**AMENDMENT NO. 2 (02/ 2019)**

**AIS-119 (Rev 1): 2016 Specific Constructional Requirements  
for Sleeper Coaches**

**AMENDMENT NO. 1    28 September, 2016**

**AIS-119 (Rev 1): 2016 Specific Constructional Requirements for  
Sleeper Coaches**

**Fig. 1**  
**Berth/ Seat Layouts**

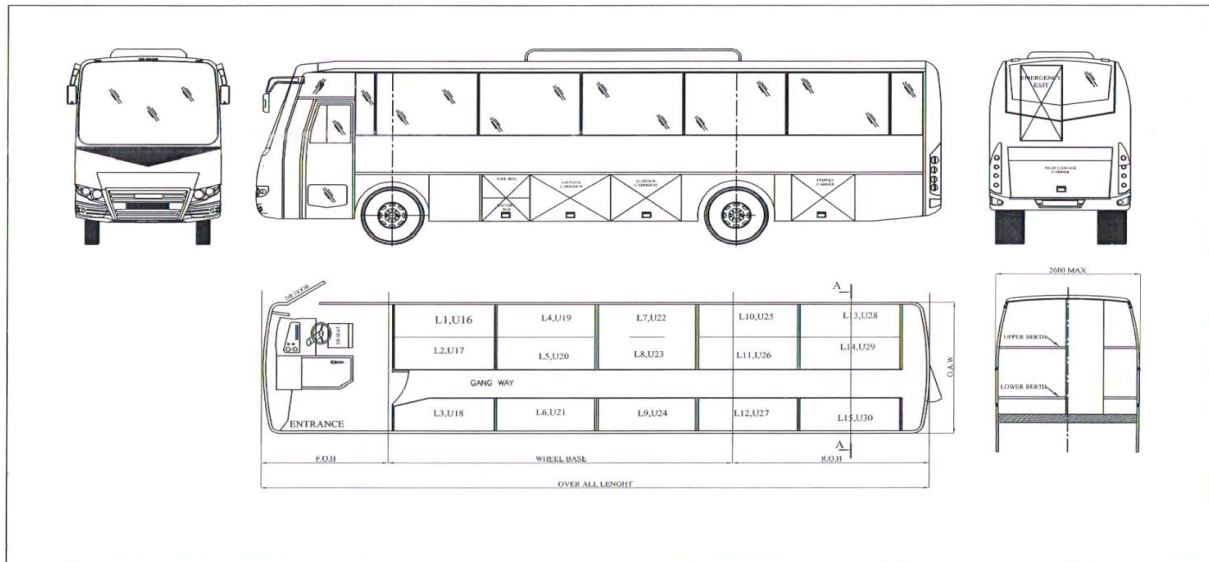
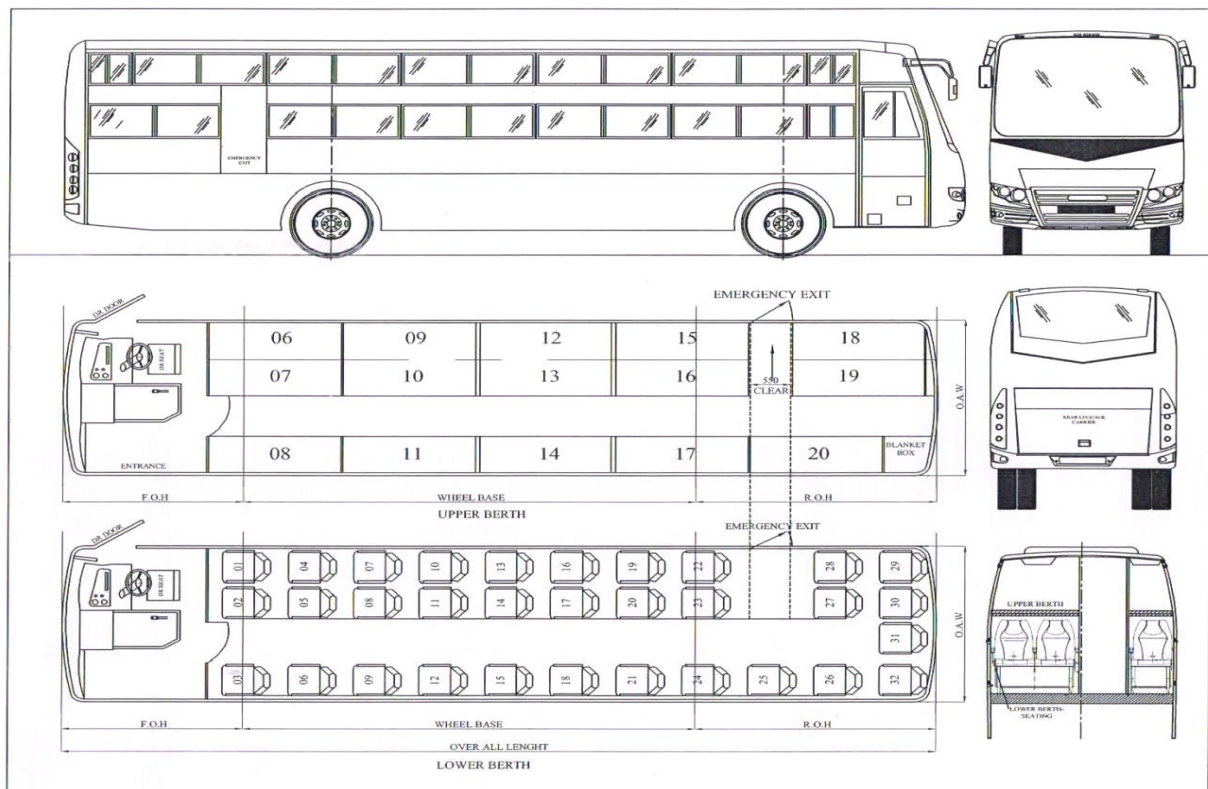
Substitute following text for existing text of clause No. 4.4.1.2

“4.4.1.2 Berth layout shall be 1x2 type or 1x1 type for berth orientation along the longitudinal axis of the vehicle. Pictorial illustration is given in Fig.1 of Appendix I. In case of rear engine buses, the lower berth lay out shall ensure that, no berth will be located on top of the engine compartment to avoid safety against fire risk and discomfort from noise and vibration.”

**4.    Clause Nos. 4.4.1.2, 4.4.1.3 and 4.4.4.2.2**

Substitute “2X1” for “1X2”
